**XK/XJ SERIES  
VEHICLE CARE  
HANDBOOK  
SUPPLEMENT**

**JJM 10 16 18/001**

## Engine Lubrication System

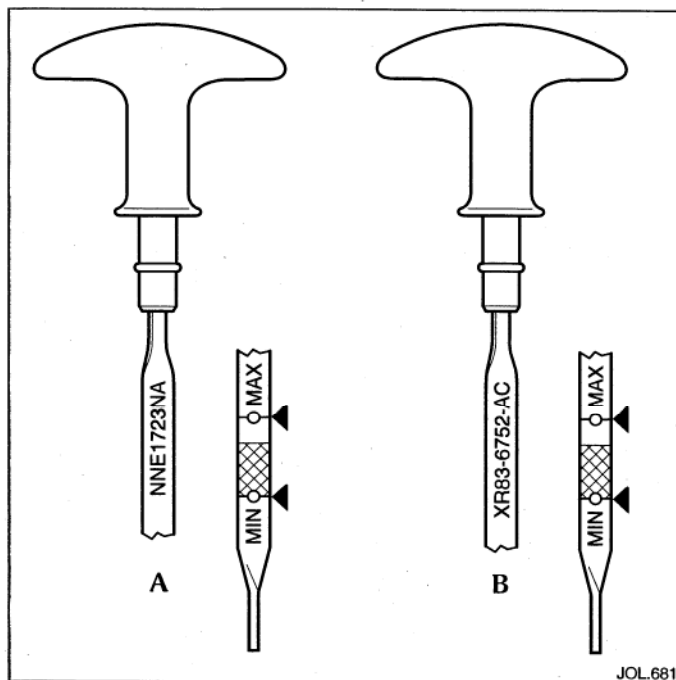
Modifications have been made to the engine lubricating system, part of which, is a new dipstick and an increase in oil capacity. The modifications were effective from the following VINs:

Both versions of the dipstick look similar, but may be identified by the part number stamped near the top. These are:

Pre-modification ('A' on illustration) - NNE1723NA.

Modified version ('B' on illustration) - XR83-6752-AC.

As a result of the modifications, the oil capacity for 3.2L, 4.0L, Normally Aspirated and Supercharged engines has increased nominally by:

1 Litre (1,75 Imp Pints) (1.06 US Quarts).
